Office Action Summary

10/588,463

DETAILED ACTION

Fig B

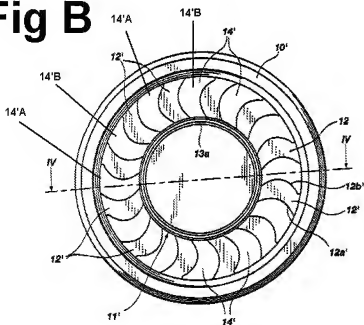
Guala, however, teaches a diaphragm valve 9' (Fig 2) having elongate openings 14'A (best seen in Fig B below) which are uniformly distributed along a circle in the periphery of the diaphragm (as seen in Fig 2) wherein the elongate openings are separated from one another by webs 12' (Fig 2) and compact openings 14'B (best seen in Fig B below) which are present adjacent to the webs (as seen in Fig B below) for the purpose of allowing communication between two passageways (Col 5, Lines 41-43). Therefore, it would have been obvious to one of ordinary skill in the art at the time the invention was made to modify Samson to include a diaphragm valve having elongate openings and compact openings separated by webs, as taught by Guala, for the purpose of allowing communication between two passageways (Col 5, Lines 41-43).

Guala, however, teaches a diaphragm valve 9' (Fig 2) having elongate openings 14'A (best seen in Fig B above) which are uniformly distributed along a circle in the periphery of the diaphragm (as seen in Fig 2) wherein the elongate openings are

Guala, however, teaches a diaphragm valve 9' (Fig 2) having elongate openings 14'A (best seen in Fig B above) which are uniformly distributed along a circle in the periphery of the diaphragm (as seen in Fig 2) wherein the elongate openings are separated from one another by webs 12' (Fig 2) for the purpose of allowing communication between two passageways (Col 5, Lines 41-43). Therefore, it would have been obvious to one of ordinary skill in the art at the time the invention was made to modify Samson to include a diaphragm valve having elongate openings separated by webs, as taught by Guala, for the purpose of allowing communication between two passageways (Col 5, Lines 41-43).

Fig D

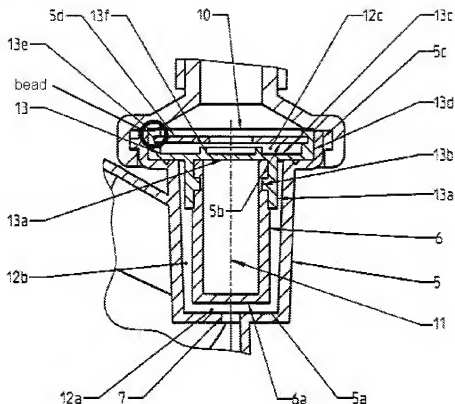
26. Re claim 36, Samson/Guala disclose all the claimed features except that the cylindrical jacket is provided with a bead extending at least partially about the circumference. Nuesch, however, teaches a cylindrical jacket 13d (Fig 3) having a bead (formed above groove 13e as seen in Fig D below) extending about the circumference for the purpose of holding parts of the valve in a specific configuration (Col 4, Lines 26-27). Therefore, it would have been obvious to one of ordinary skill in the art at the time the invention was made to modify Samson/Guala to include a bead, as taught by Nuesch, for the purpose of holding parts of the valve in a specific configuration (Col 4,
